## Permit Revision Submittal Requirements and Application

Description of revision Removed cantilevered glass wind baffle from scope of work.

PERMIT REVISION  
07.06.2018

# EXTERIOR IMPROVEMENTS

Elevations

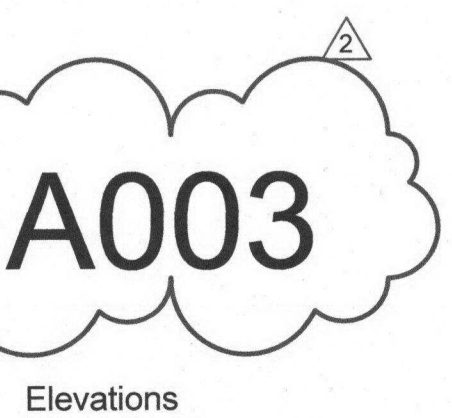
SCOPE REMOVED FROM PROJECT
